179 MAIN STREET (COMPLETE APPLICATION)
DE416774 - ZONE DEOD - Sub-Area 1

DEVELOPMENT PERMIT STAFF COMMITTEE MEMBERS

DEVELOPMENT PERMIT STAFF COMMITTEE RECOMMENDATION: APPROVE

GROUND FLOOR
LANDSCAPE PLAN

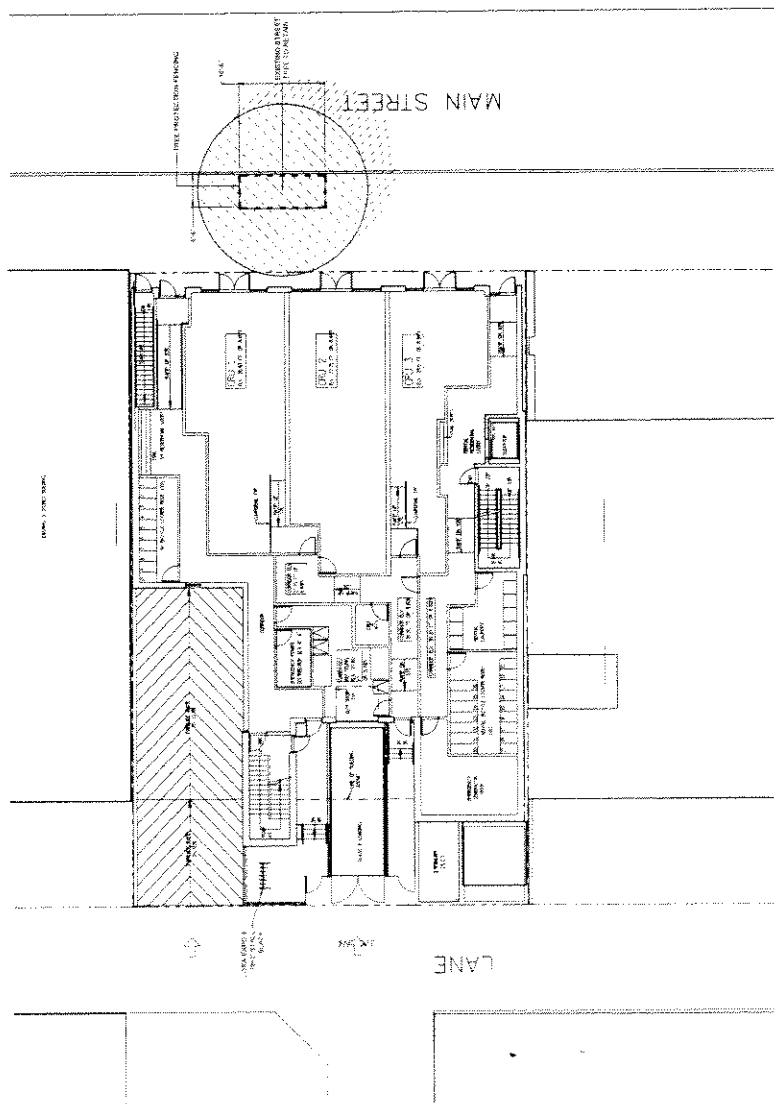
- A1.23 provision of alternative tree protection for the existing street tree and deletion of tree barriers detail sheet L1;

Note to Applicant: Standard barriers cannot be installed in concrete sidewalk strips. Suggest metal hoarding panels be used, with a notation on the plan.

LEVEL 2, 3 & ROOF
LANDSCAPE PLAN

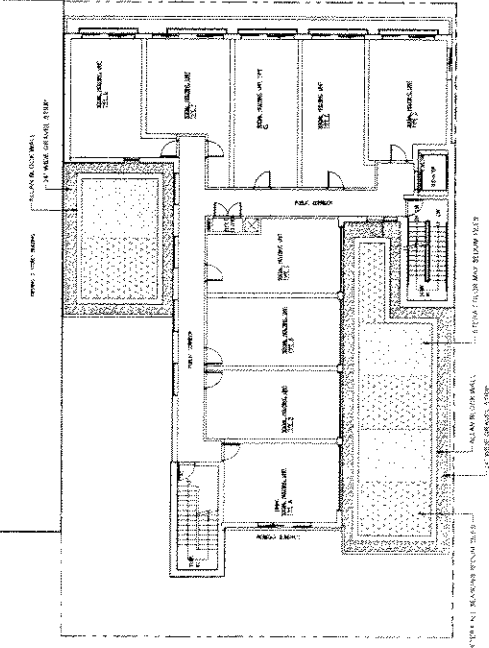
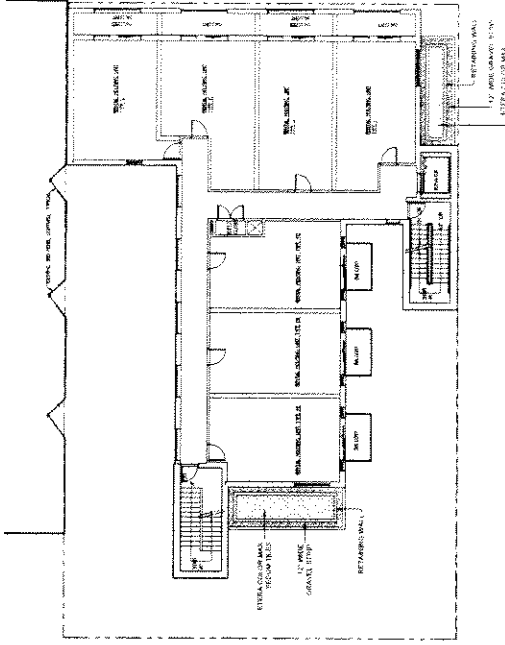
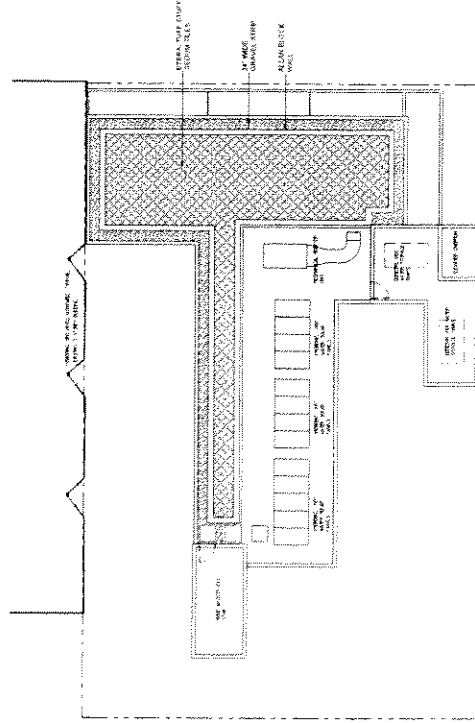
- 1.5 provision of common access outdoor space at the top roof level for residents;

Note to Applicant: Intent is to provide a sunny, secure and generous green space within the site where all residents can socialize and enjoy nature.

Staff note that the rooftop offers excellent sunlight exposure and a quieter environment, and recommend that this level be developed as common access outdoor space (see Condition 1.5). The amount of rooftop garden that may be excluded from FSR is not limited by the ODP. This larger space, if appropriately landscaped, also offers an opportunity to experience nature and seasonal change in a way not feasible on individual balconies. Finally, given the removal of the significant conifer proposed to accommodate parking, staff recommend provision of an additional street tree (see Standard Condition 1.22).
